Village of Bayside
9075 N Regent Road
Architectural Review Committee Meeting
June 5, 2023
Village Board Room 6:00pm

ARCHITECTURAL REVIEW COMMITTEE AGENDA

Attention:
Village of Bayside, WI
Architecture Review Committee

VILLAGE CODE REVIEW

PROJECT/SITE OWNER:	PROJECT SUMMARY:
Mark & Jo Gassner PROJECT ADDRESS: 8425 N Greenvale Rd.	New 6-foot by 24' 6" wooden privacy fence, 4-foot by 65 feet white cedar open design fence and red cedar pergola

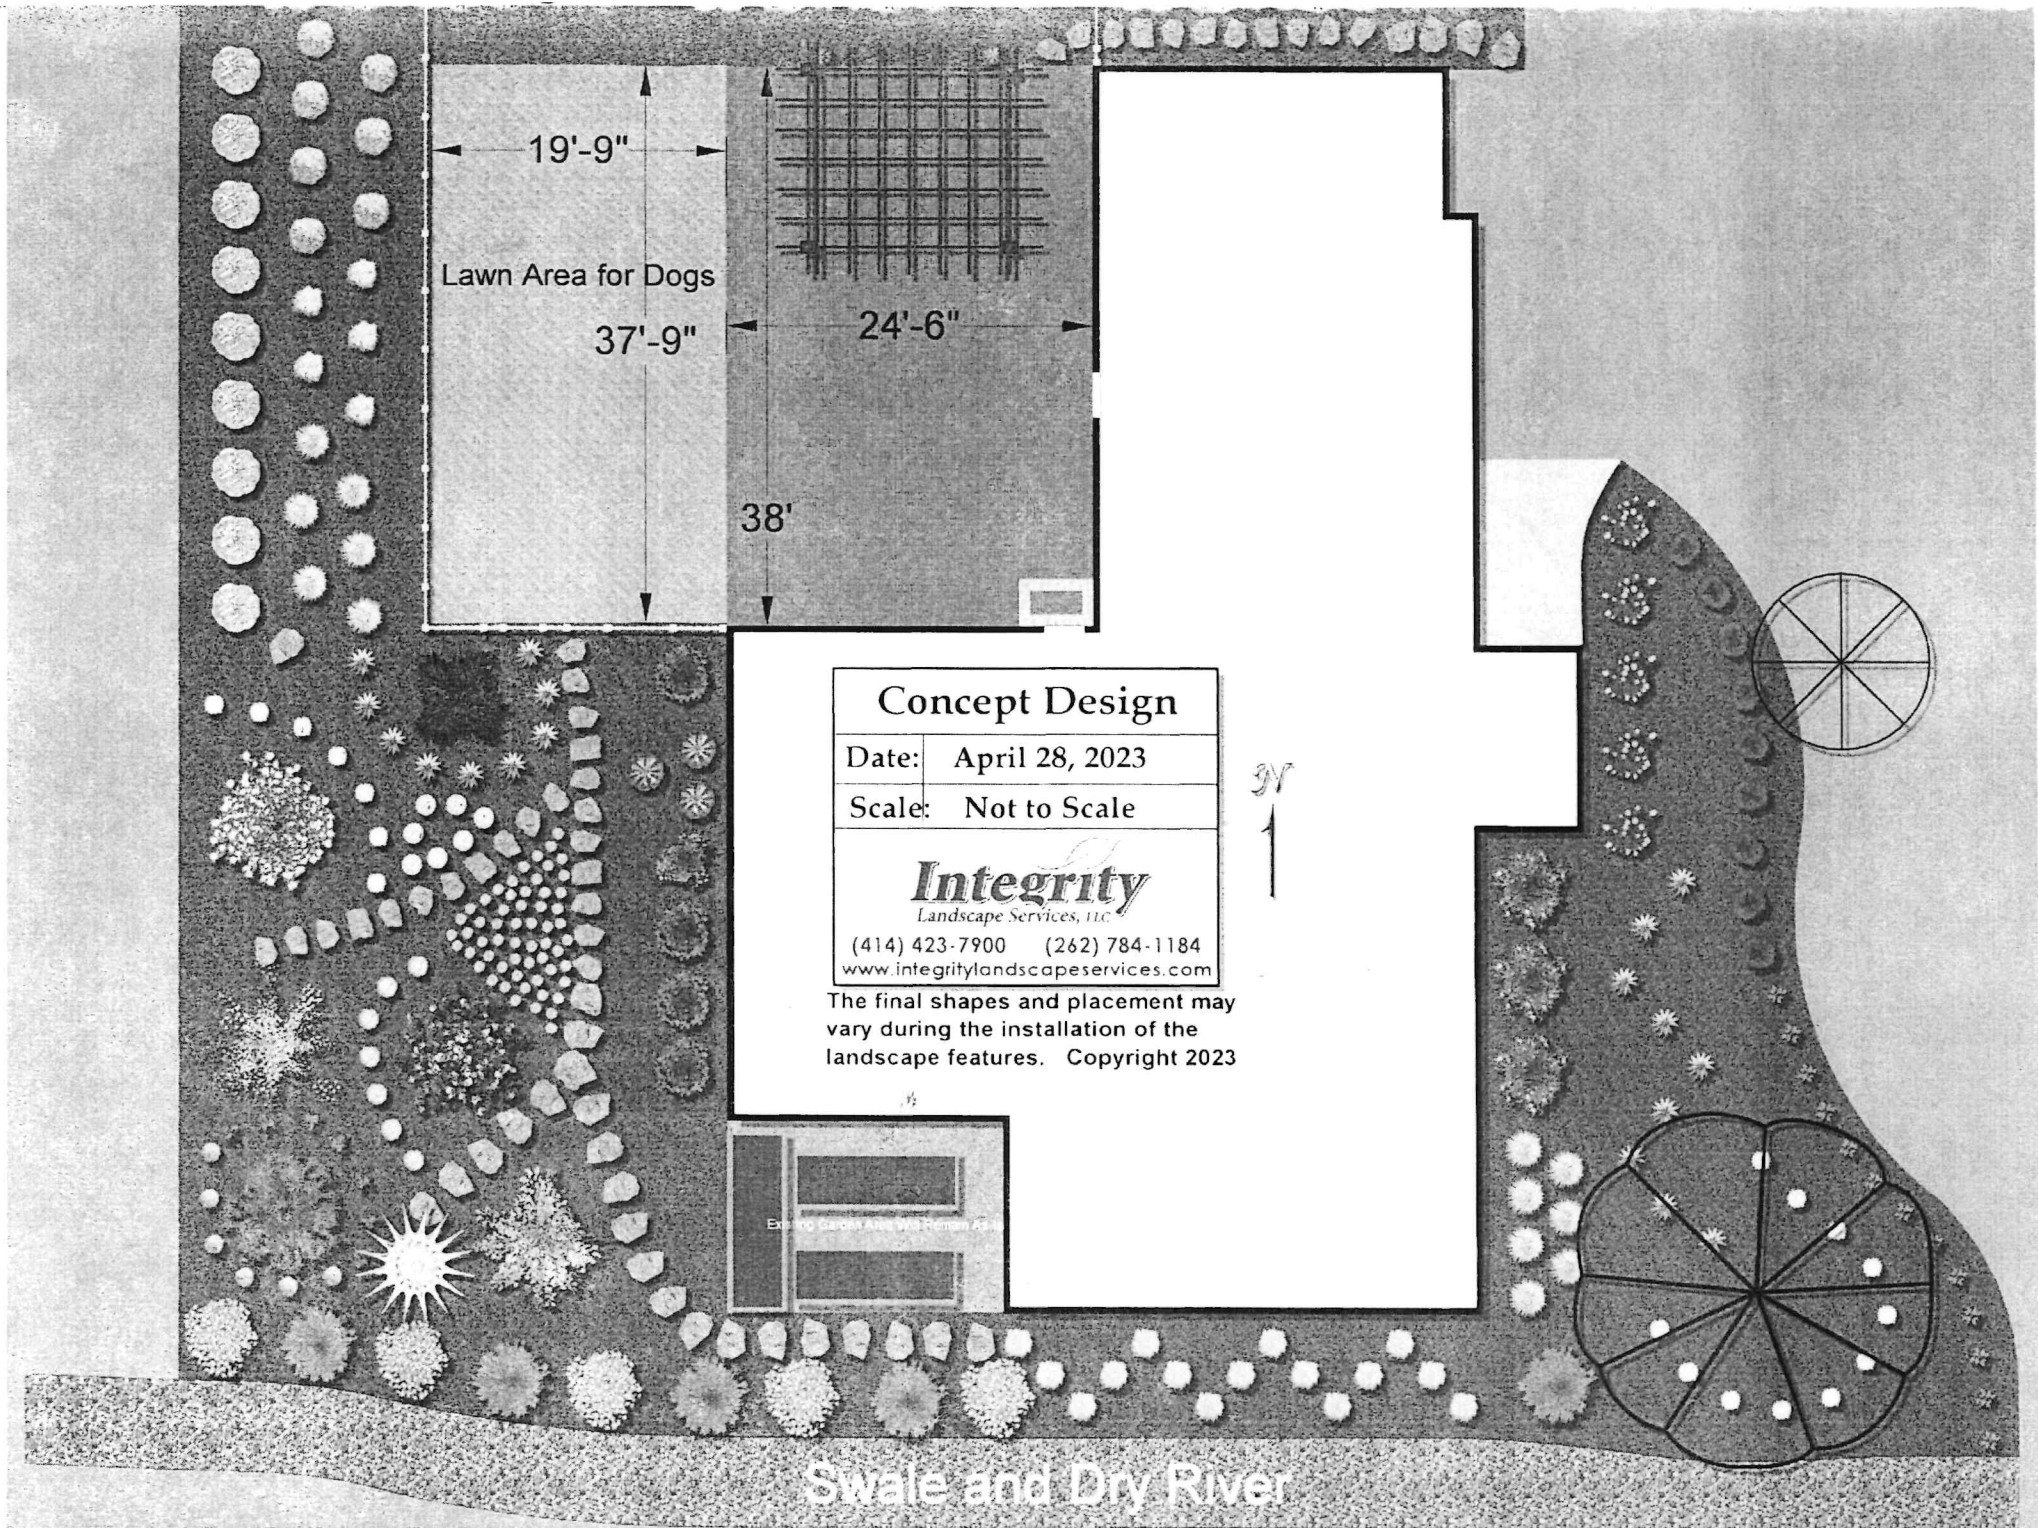
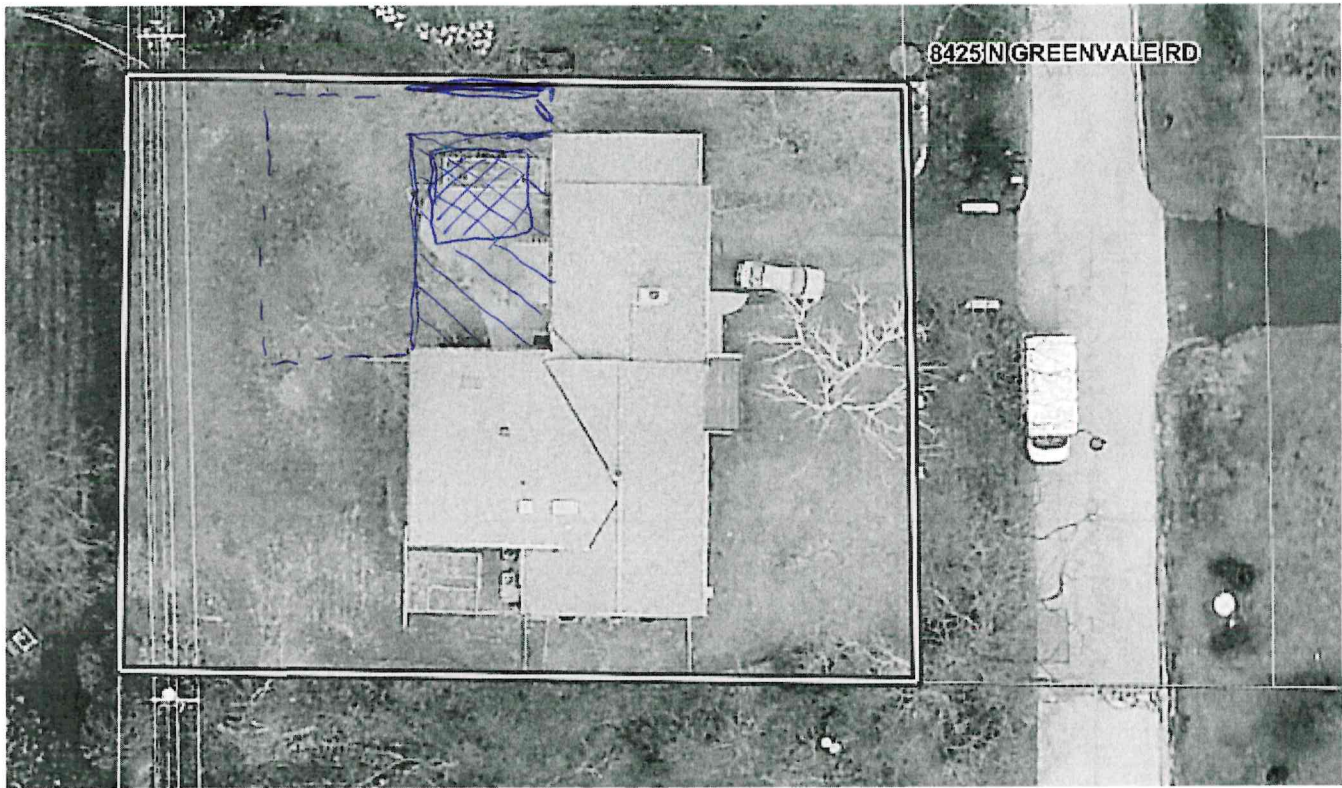
1. The 4-foot-high fence design having face panels of two inches wide with 2 inches of separation, complies with the 50% open design requirement in the ordinance.
2. The 6-foot high by 24' 6" privacy fence complies with the requirements of the ordinance.
3. The pergola shown on the drawing complies with the requirement of setback within the ordinance.
4. The board always considers matching fences with neighboring fences.
